**TOWN OF OCEAN RIDGE
PLANNING & ZONING REGULAR MEETING
AGENDA**

**March 17, 2026 at 9:00 AM
Town Hall - Meeting Chambers**

To:	Planning & Zoning Board Members
From:	Corey O’Gorman, Town Planner
Meeting Date:	March 17, 2025
Subject:	20 Hudson Avenue – Development Plan Review

PLAN REVIEW REPORT
20 Hudson Avenue
01/04/26/Revision 02/02/26

A200

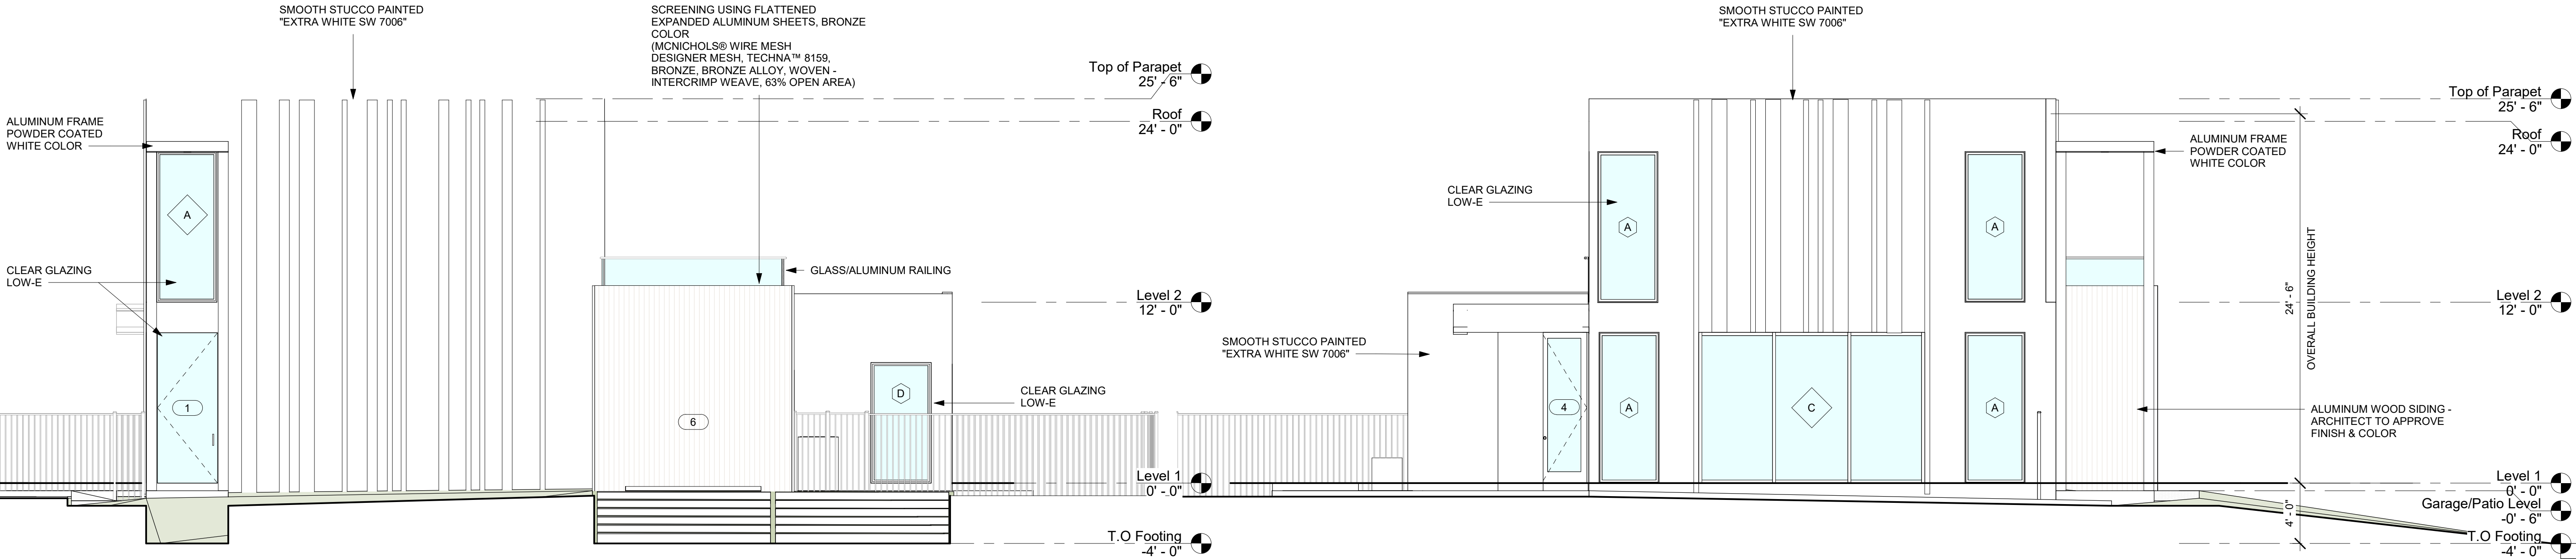
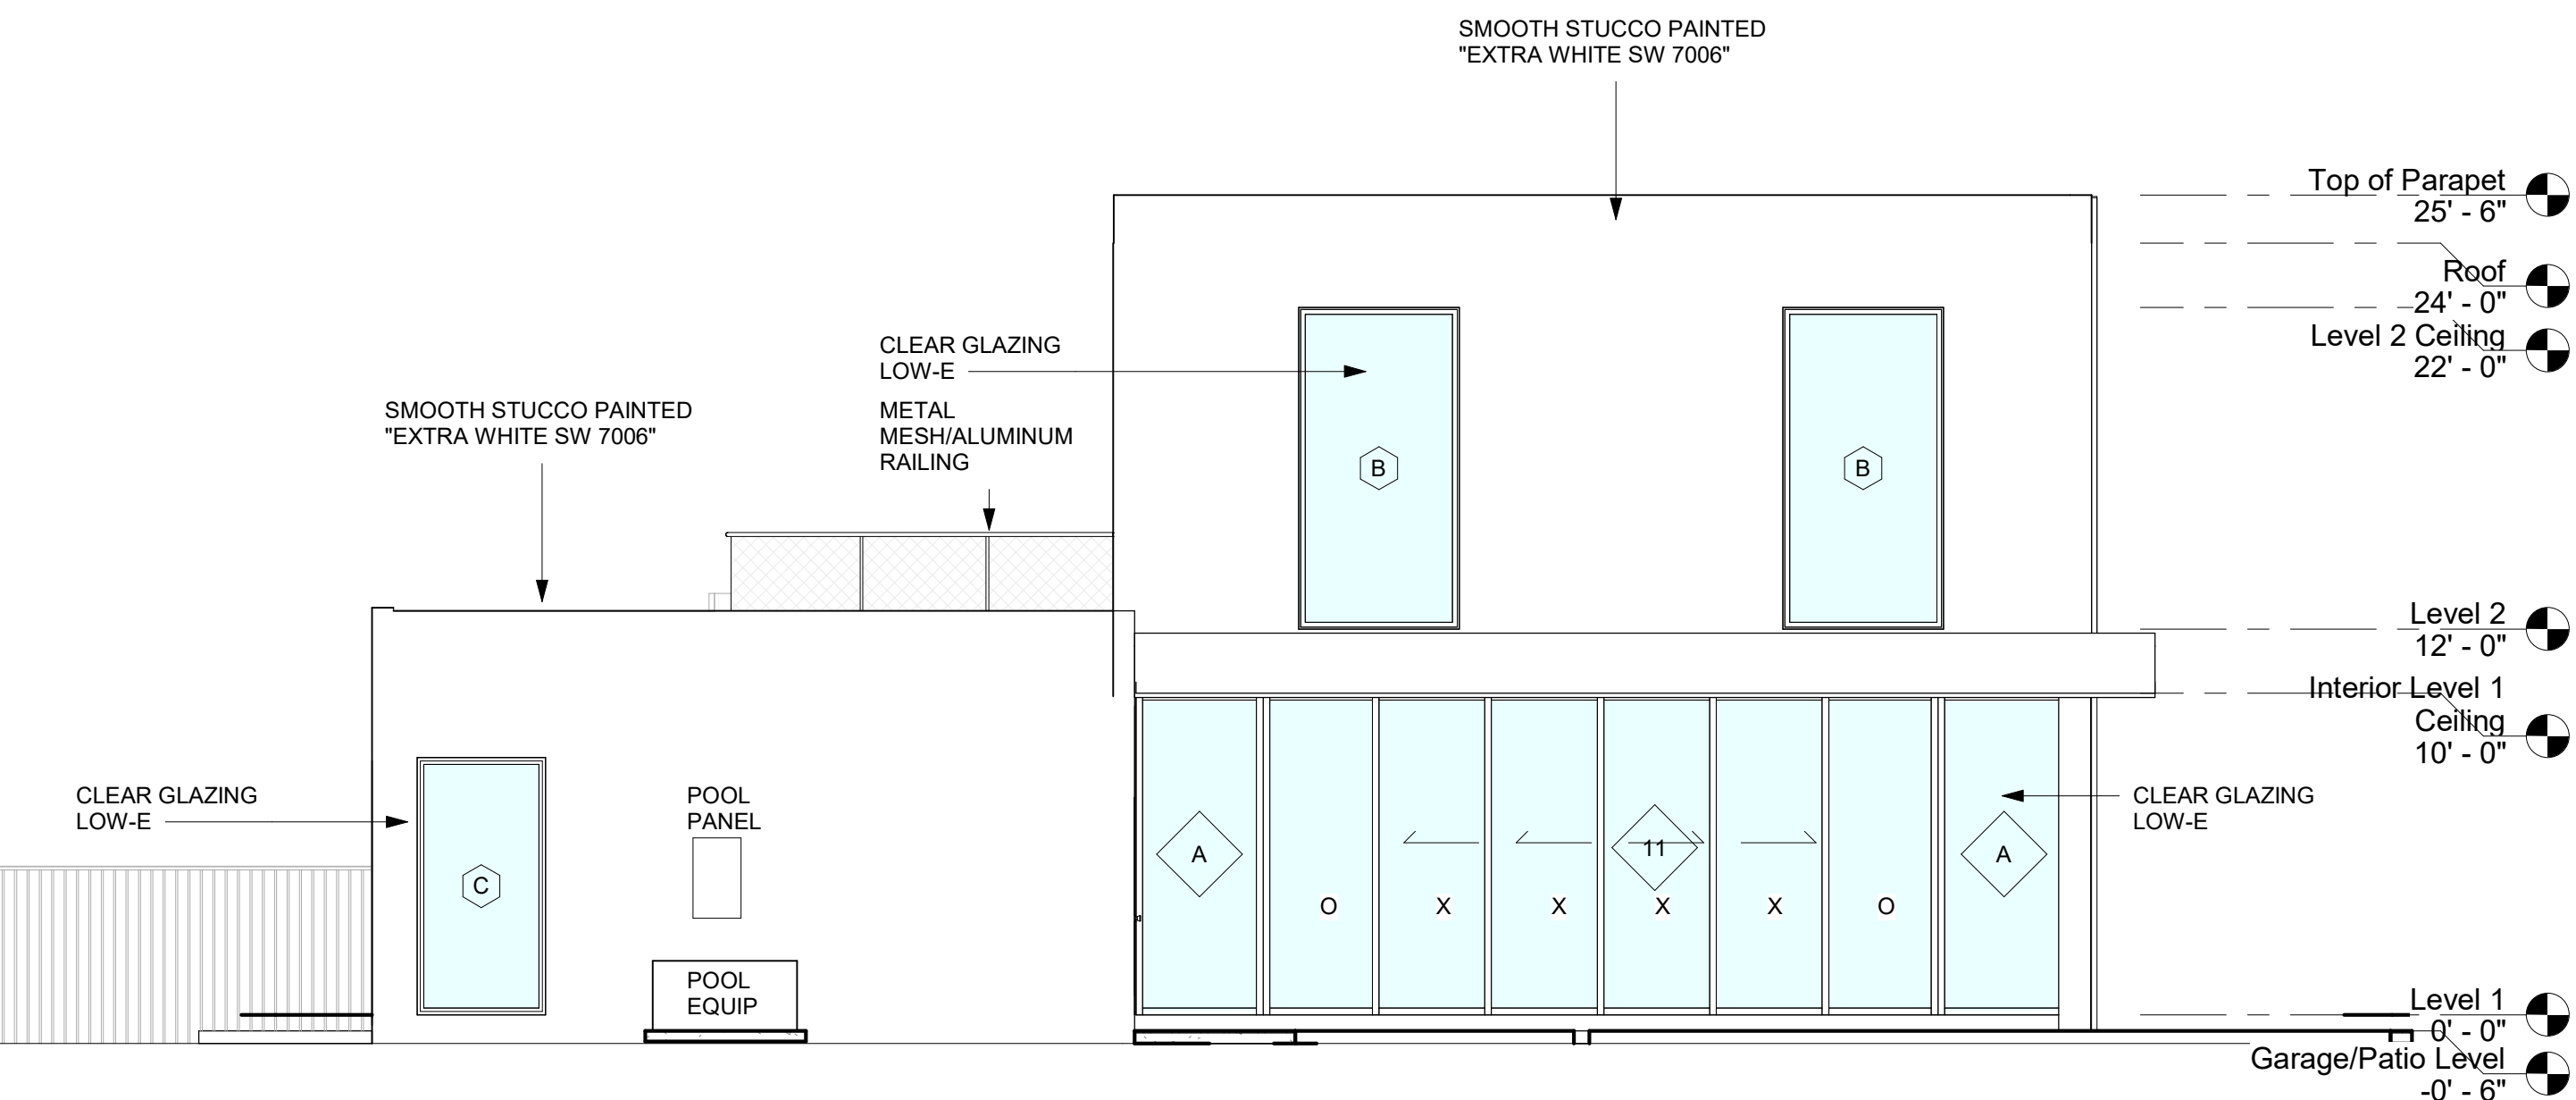
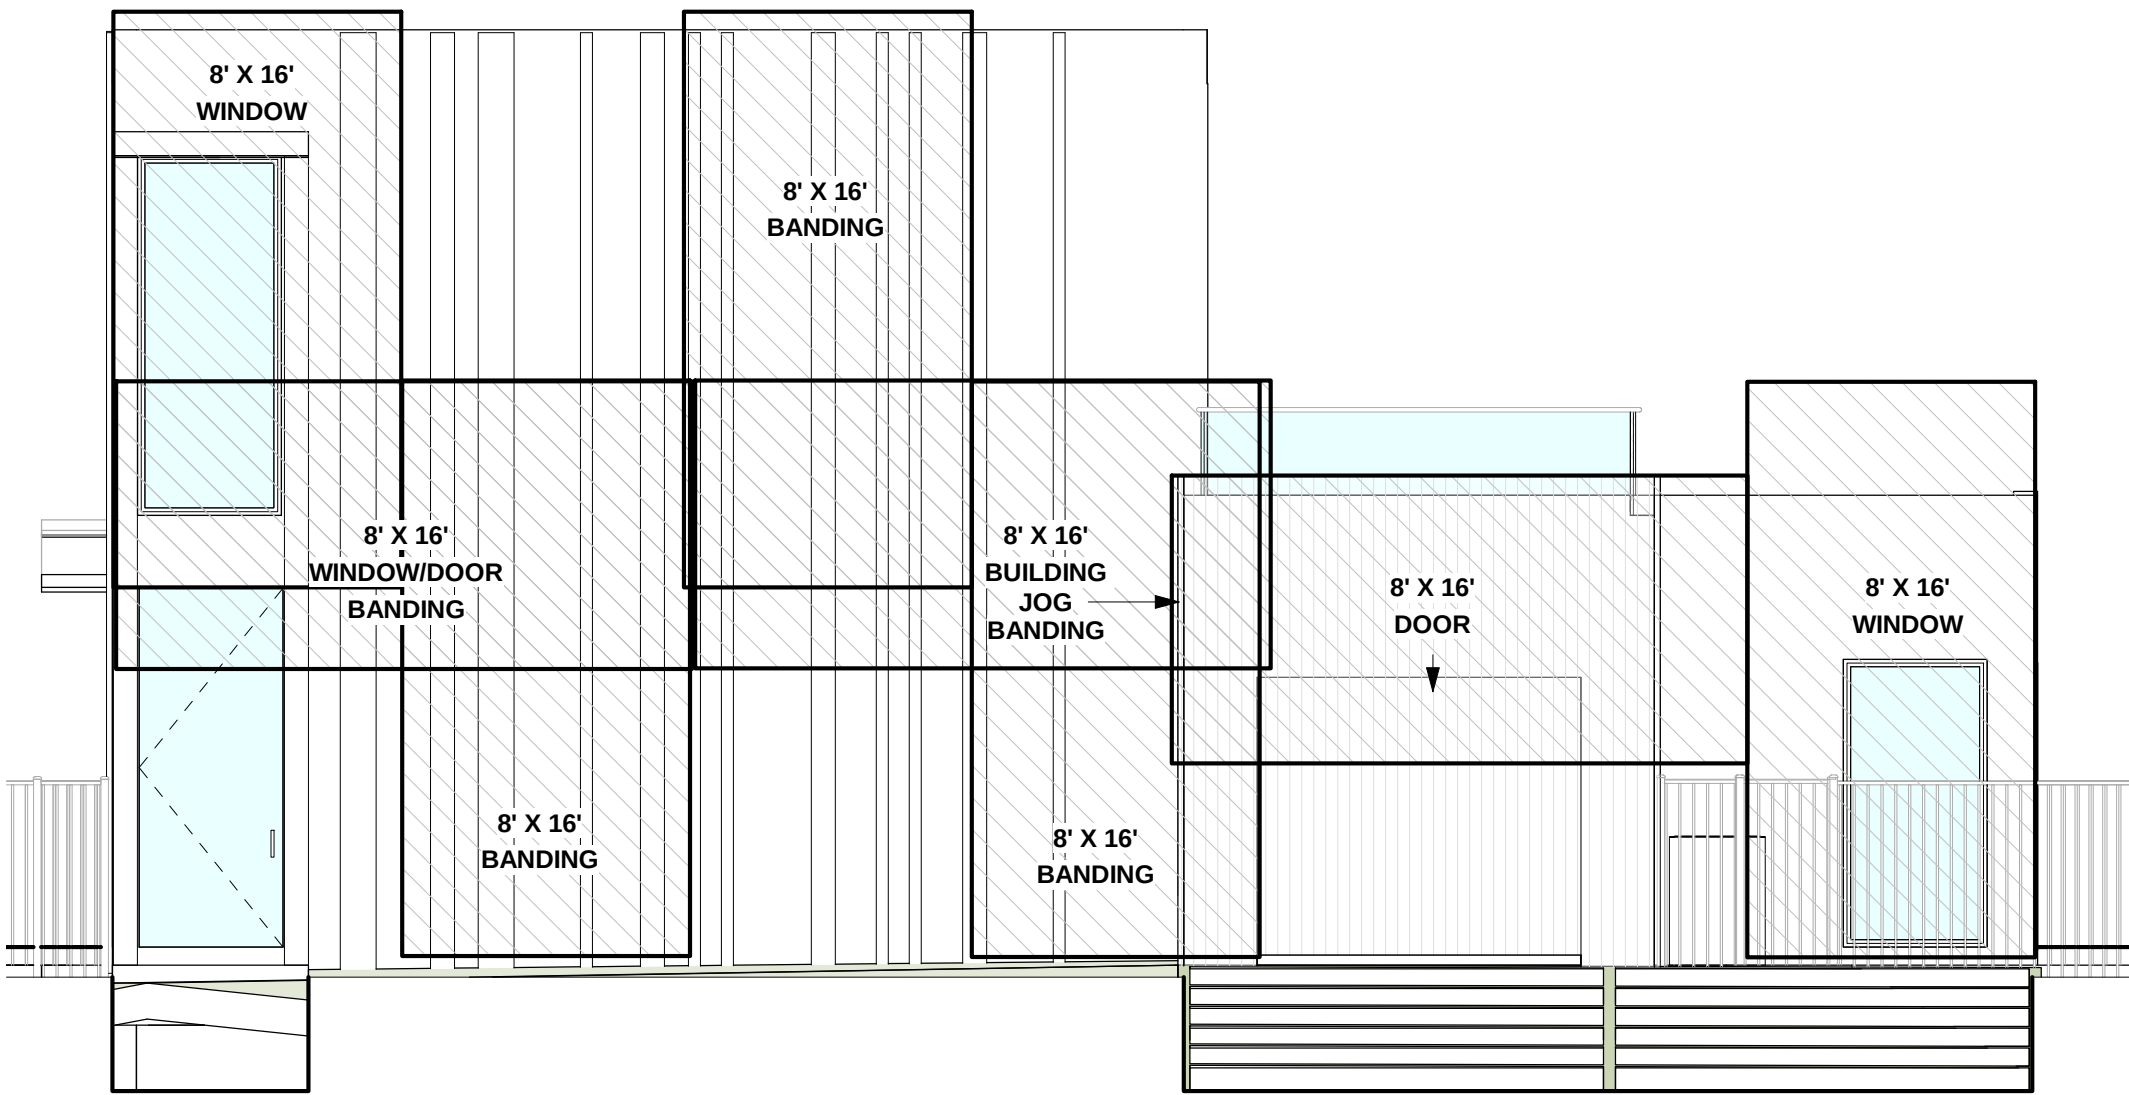
elevation must touch or overlap an element such as a window or door, or a significant articulation such as shutters, decorative arches, building jog, or banding. Sheet A200 shows that the east and south meet the minimum requirement of 15 percent for windows and doors. However, on the west side, the percentage is 14.98 and on the north side, it is 14.96, both of which do not comply with the 15 percent minimum requirement. In addition, the West Elevation on Sheet A201 shows elevation coverage by the "8x16 Rectangle" described in this code section, however the area between the two window openings on the 2nd floor scales at approximately 20' horizontally by 15' vertically.

Comment: Please revise Sheet A200 to comply with the minimum 15% window openings and revise the West Elevation on Sheet A201 to comply with the maximum articulation requirements. **Comment addressed**
